**BCC DS**  
**RECEIVED**  
08-MAY-2026  
**APPLICATION REF**  
A007020190

DA Set - 21.02.2024.

DA Set - 15.02.2026.

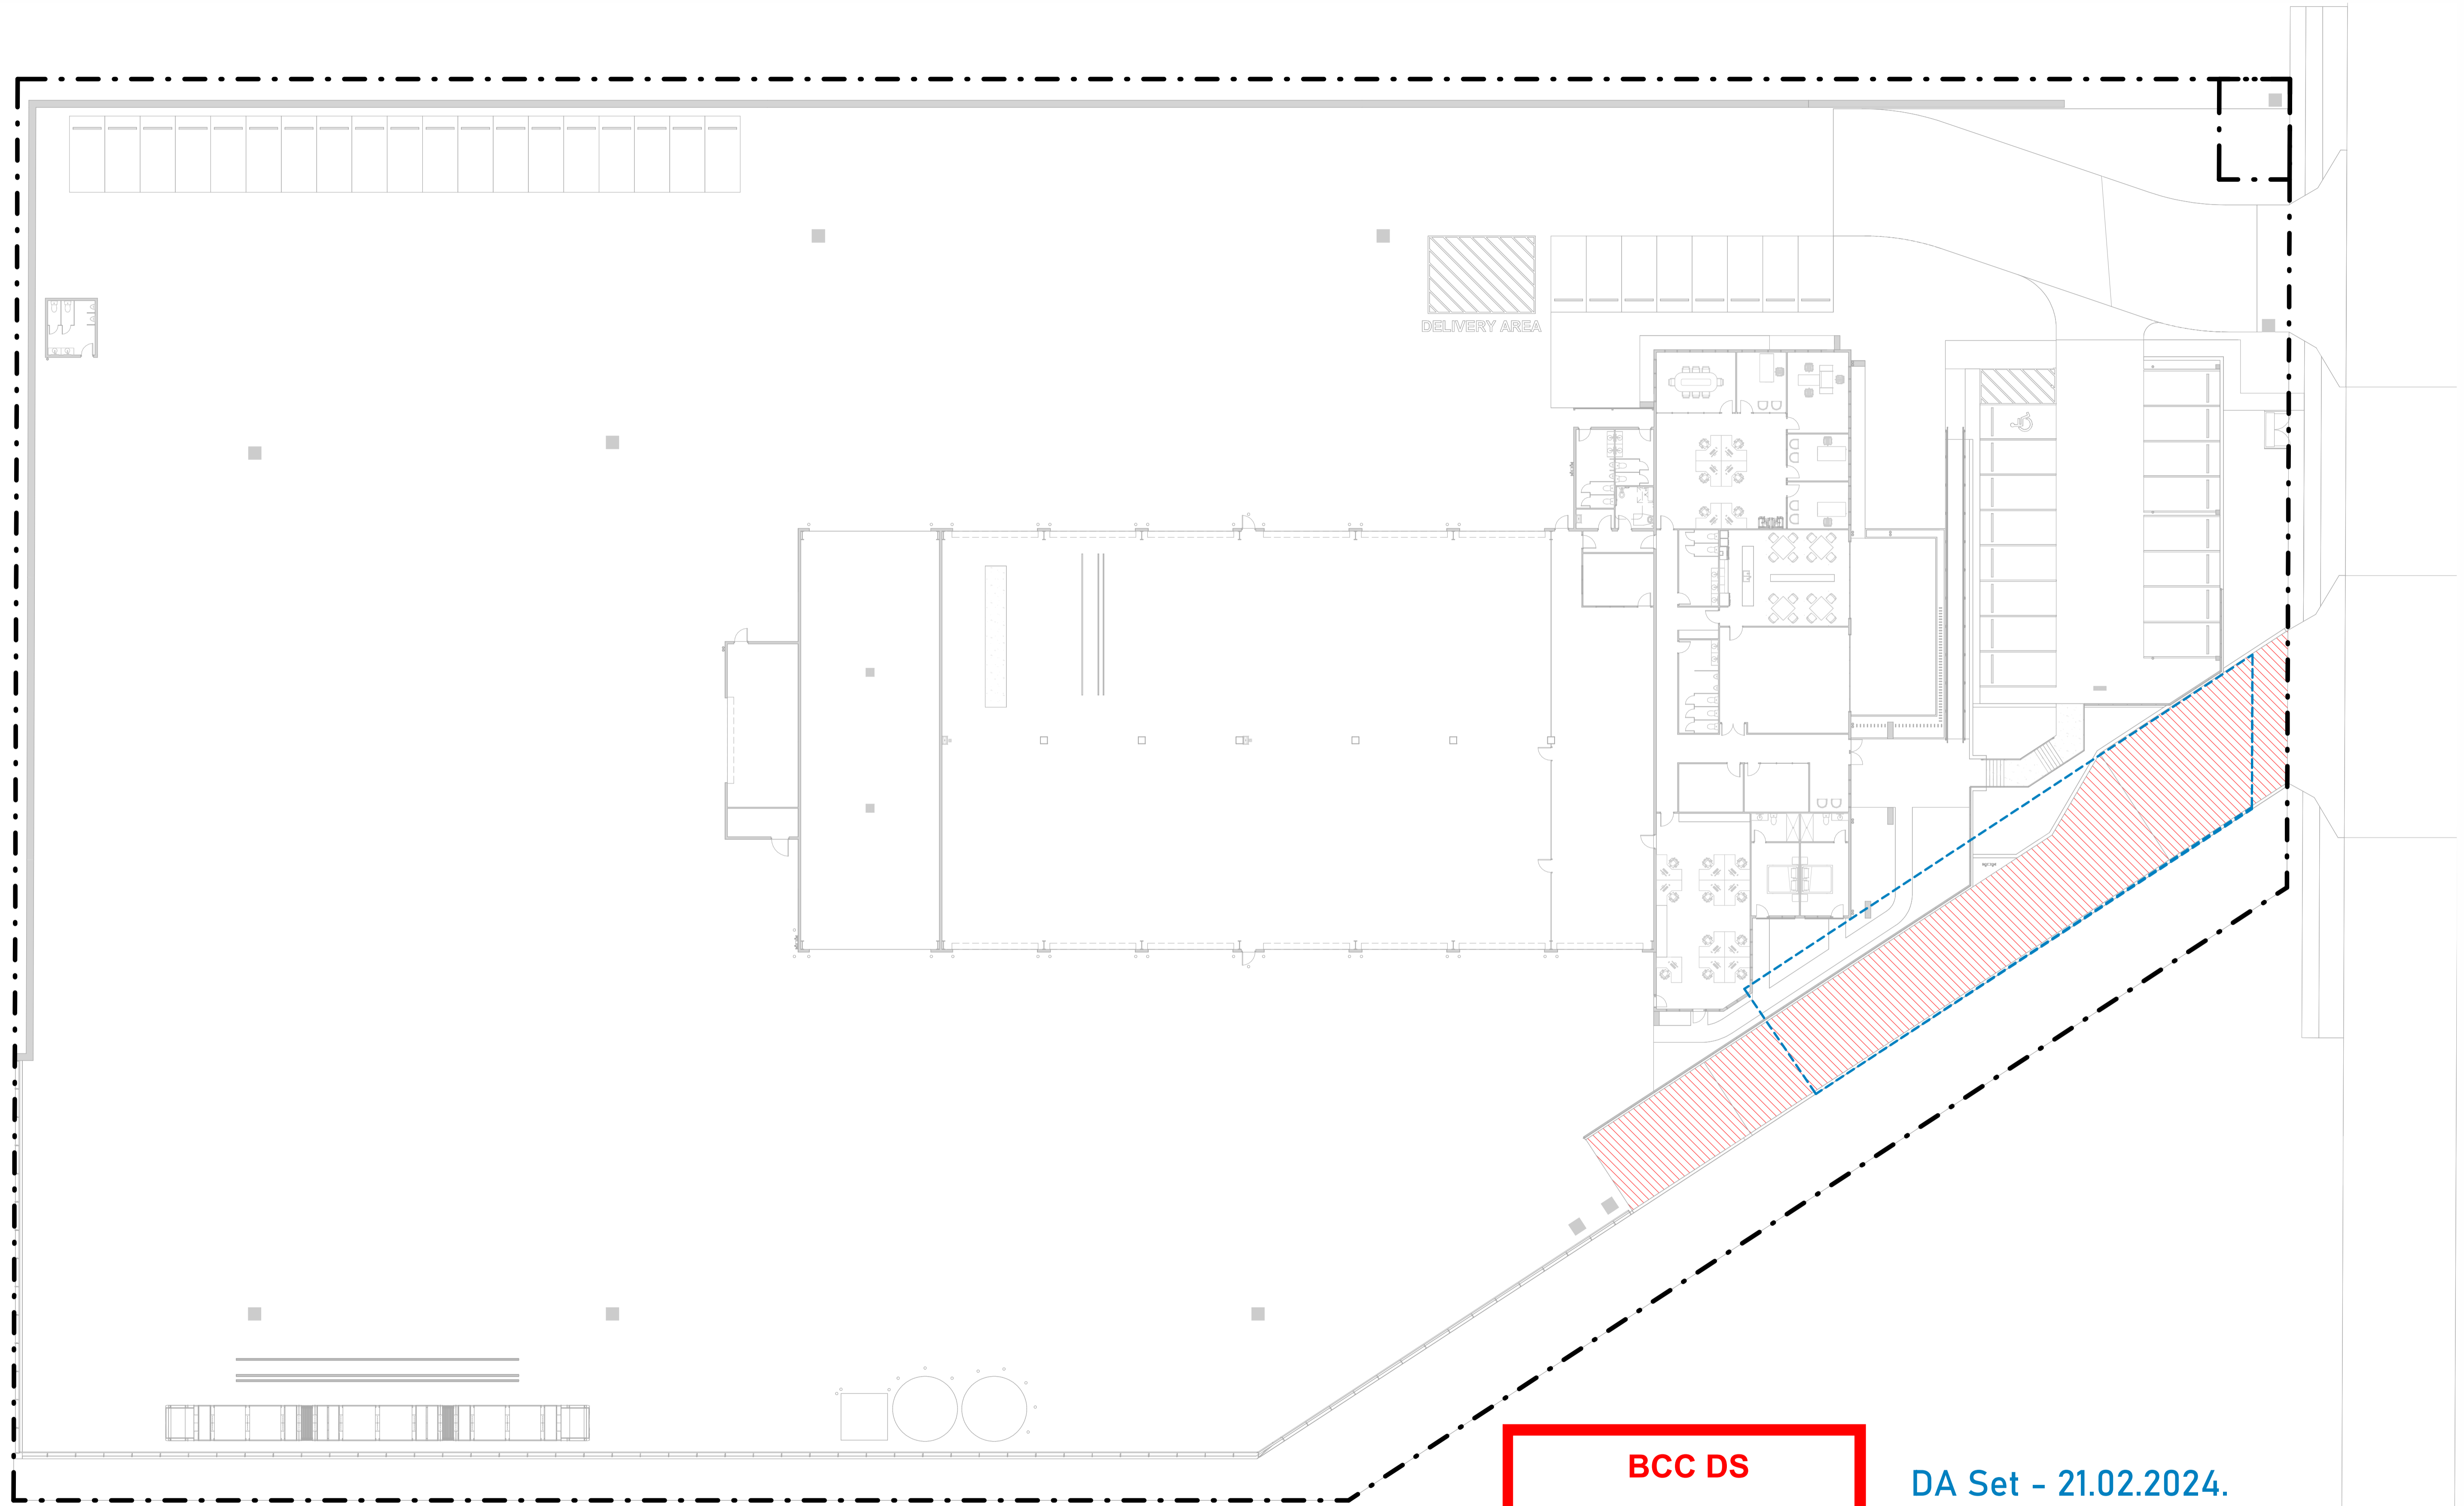
19. The access ramp has been extended and widened to improve truck entry and exit on site.
